Permit No.: B18002913

Existing Use: SINGLE FAMILY HOME
Proposed Use: SINGLE FAMILY HOME
Estimated Construction Cost: \$ _____
Description of Work: ADD SUN ROOM IN PLACE OF EXISTING DECK - BUILD NEW DECK

Project Name and Address: 14034 Burntwoods Road, Glenelg, Maryland

Issue(s) to be Reviewed: Construction of rear enclosed porch without a permit

LOCATION DRAWING

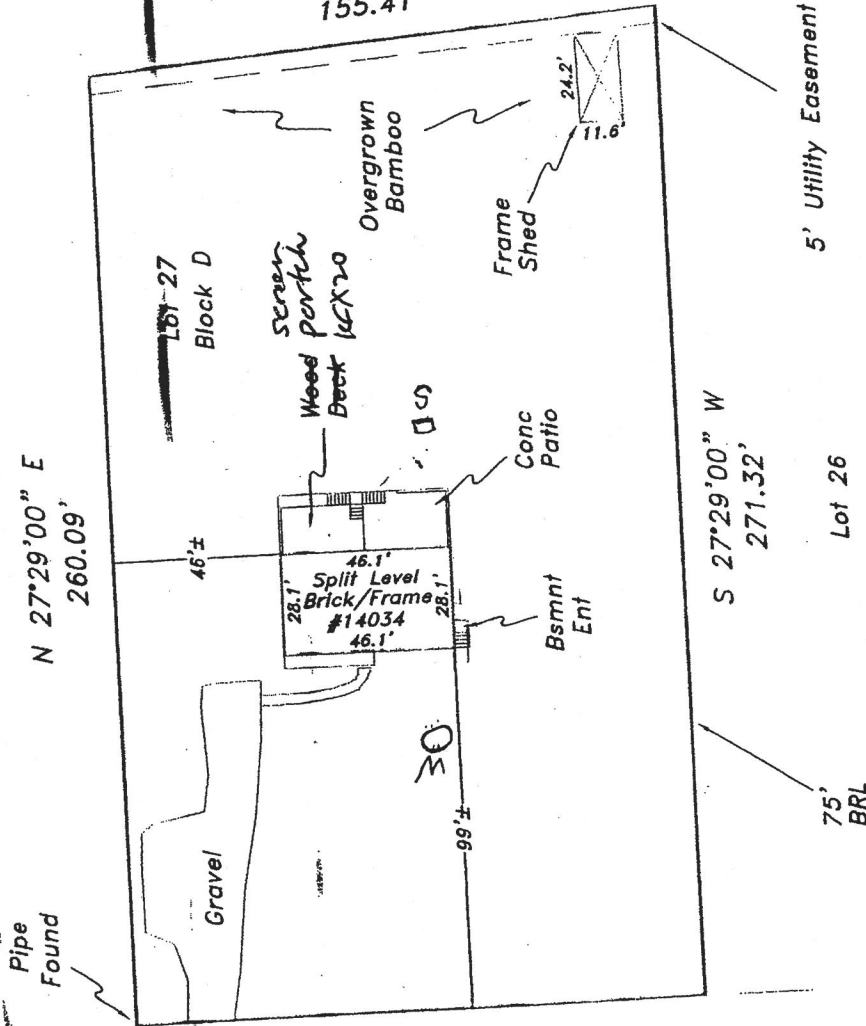
Okay to walk through per Dan S.

DESC. OF WORK: Enclose existing deck into a screened porch.
Existing stairs to remain. 4x20
S 66°39'54" E
155.41'

SITE INSPECTION SHEET

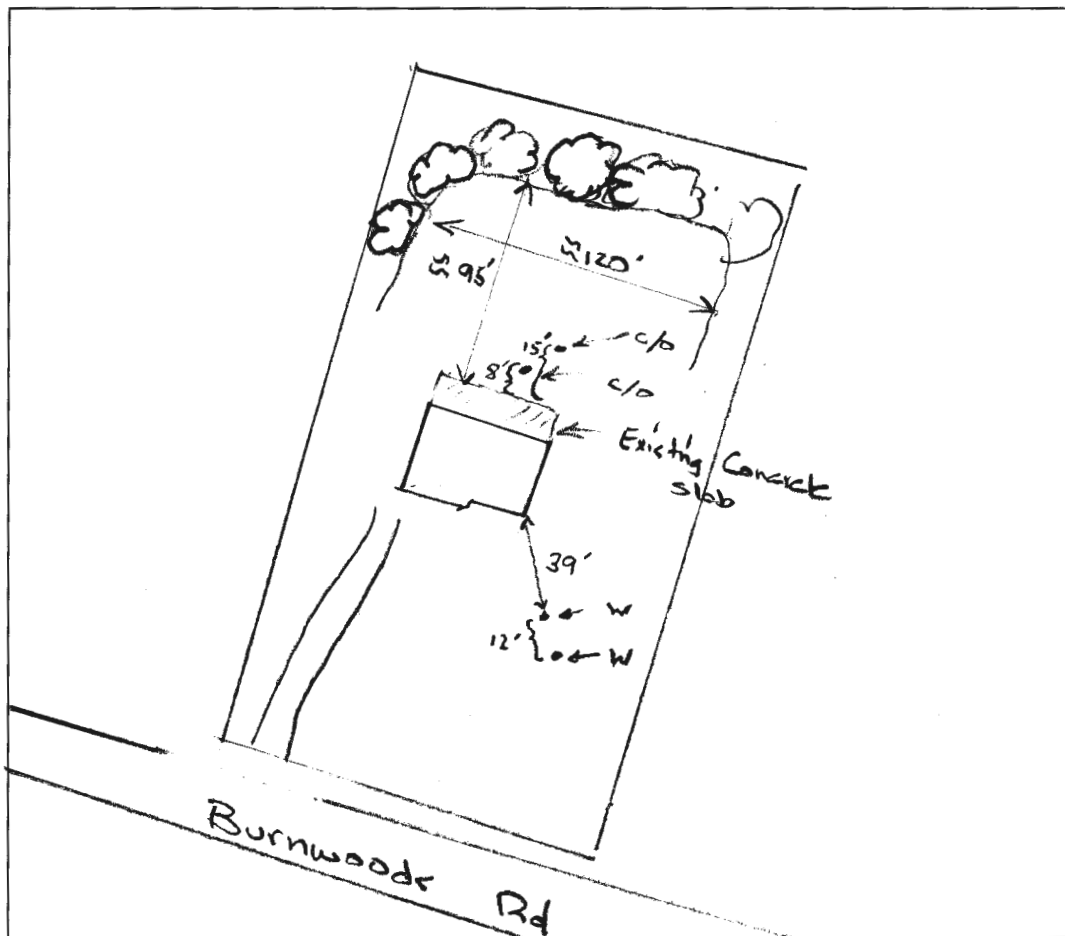
COMMENTS: Site inspection conducted. Property has 2 wells onsite. The area around c/o + SDA was dry w/ no odds.
